**UNITED STATES
NUCLEAR REGULATORY COMMISSION**
WASHINGTON, D.C. 20555-0001

FACILITY: LaSalle County Station, Units 1 and 2

SUBJECT: SUMMARY OF JUNE 28, 2012, PRE-APPLICATION MEETING WITH EXELON GENERATING COMPANY, LLC, TO DISCUSS LICENSING AMENDMENT REQUEST FOR LASALLE COUNTY STATION UNIT 1 AND UNIT 2 ULTIMATE HEAT SINK AT AT EXTENDED POWER UPRATE POWER LEVELS (TAC NOS. ME8866 AND ME8867)

Figure 3.7.3-1 (page 1 of 1)
Temperature of Cooling Water Supplied to the Plant from the
CSCS Pond Versus Time of Day Requirements

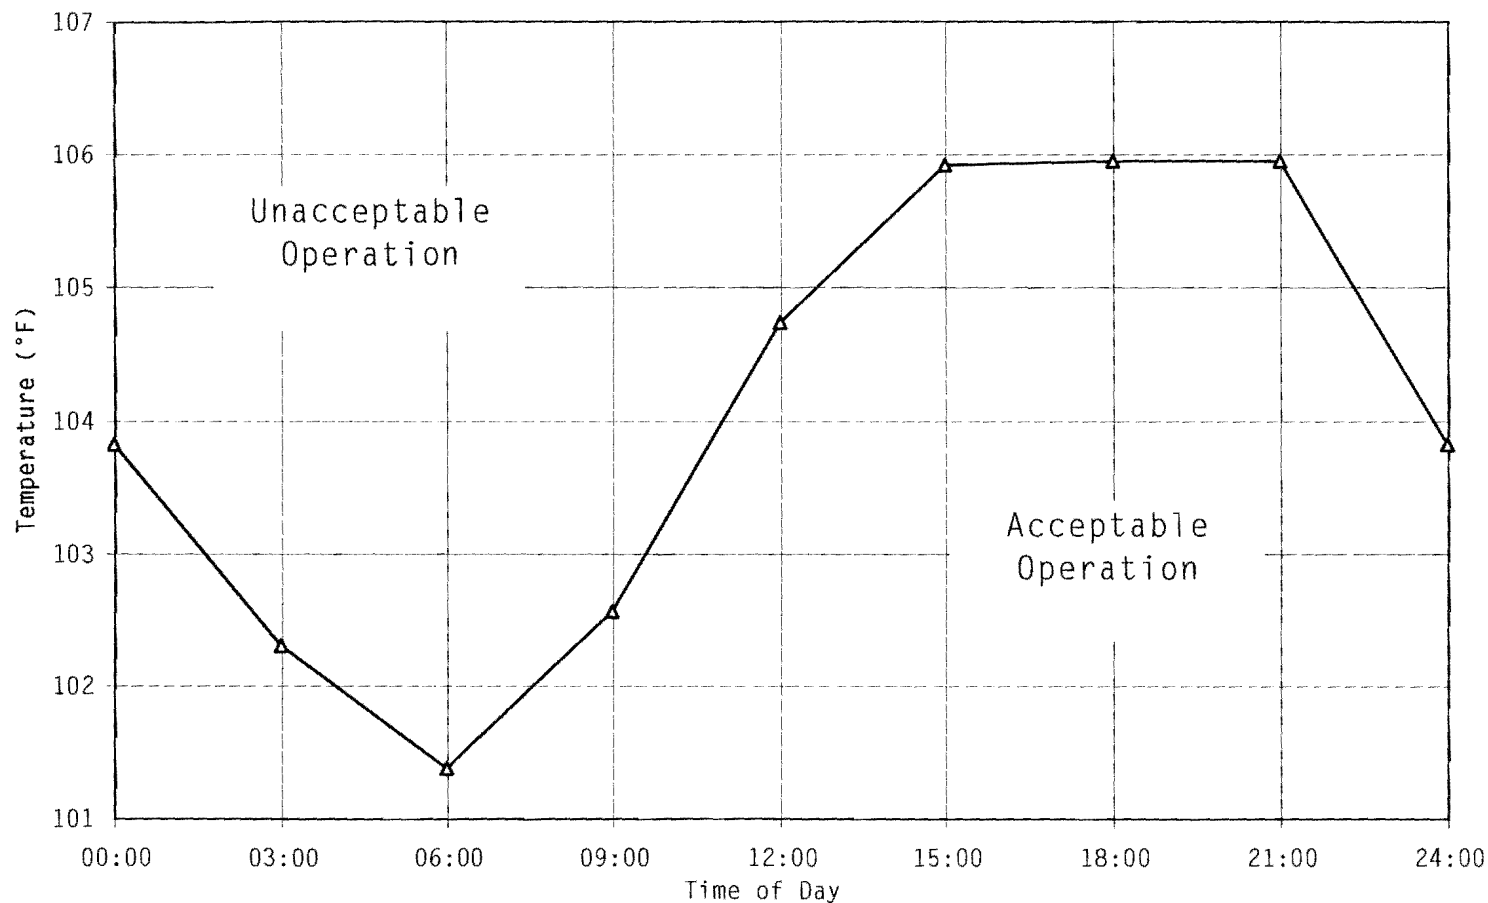
The licensee proposed a methodology that models the diurnal temperature cycle (temperature pattern that recurs daily) of the UHS heating and cooling. This approach is intended to utilize analytical margins traditionally apart of the existing linear UHS TS limit. The licensee stated that the UHS would remain conservatively below the proposed diurnal safety analysis limit of 107 °F. The staff expressed the following concerns with this proposed methodology. First, the staff questioned the analysis assumptions that only predict a 0.25 °F heat up for a design basis accident occurring at the proposed TS limit of approximately 106 °F at 3:00 p.m. Second, the NRC staff questioned whether in Enclosure 2 - Slide 16 indicated favorable weather condition for the 2nd and 3rd day of the accident. Third, the staff questioned how the licensee transitioned from the worst 24-hour period to the 2nd day of the analysis. Fourth, the staff requested that the licensee provide in their submittal the weather conditions by the hour for the first 72 hours following the accident. Fifth, given the significant number of important analysis assumptions the staff requested that the licensee describe and justify these assumptions in detail in their license submittal.
